HORSHAM DISTRICT COUNCIL CONSULTATION

TO:	Horsham District Council – Planning Dept
LOCATION:	Land North of East Street Rusper West Sussex
DESCRIPTION:	Application for Approval of Details Reserved by Conditions 3,4,5,8,9,10,11 and 12 to approved application DC/25/0523
REFERENCE:	DISC/26/0080
RE-CONSULT:	1 st set of comments in black 2nd set of comments in blue
RECOMMENDATION:	Condition 5: More Information / Modification Conditions 8, 9, 10, 11: No comments Condition 12: More Information No objection

[left: DISC/26/0080 Combined Services, right: DC/25/0523 Landscape Masterplan]

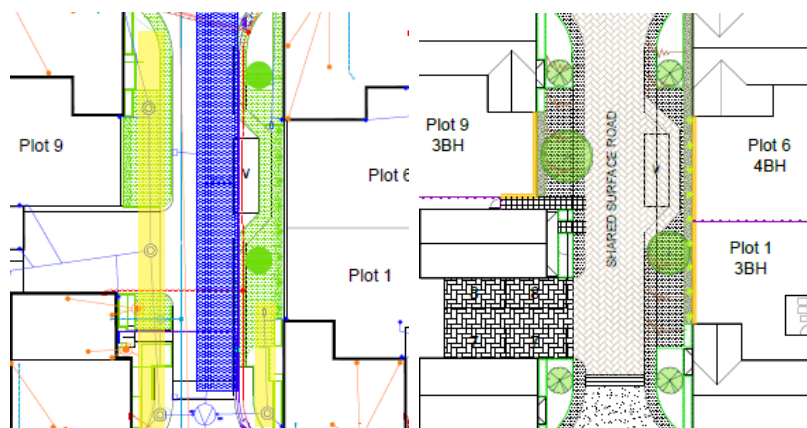
1. The combined services drawing has not been coordinated with the landscape proposals and thus we note areas of conflict with proposed trees. These plans must be coordinated and altered to ensure both strategies can be delivered, avoiding trees located within easement

zones. Please note that the proposed trees are key to the general amenity of the development and serve as landscape mitigation to retain the wooded character of the area.

The combined services drawing has now been coordinated with landscape proposals, with thanks. While areas of conflict are now resolved, 11no. trees are absent from the scheme. Slight variation in proposed locations is acceptable, however the full number of proposed trees approved under DC/25/0523 is expected to be delivered. Detailed information is not expected at this stage, however given the site constraints and proximity to underground services, details of root barriers and root cells are expected to be provided under Condition 7 to ensure successful establishment and long-term retention.

One area of potential conflict is however noted in the location below. Please adjust the drainage runs (highlighted in yellow) to ensure the previously proposed trees can still be delivered in this location.
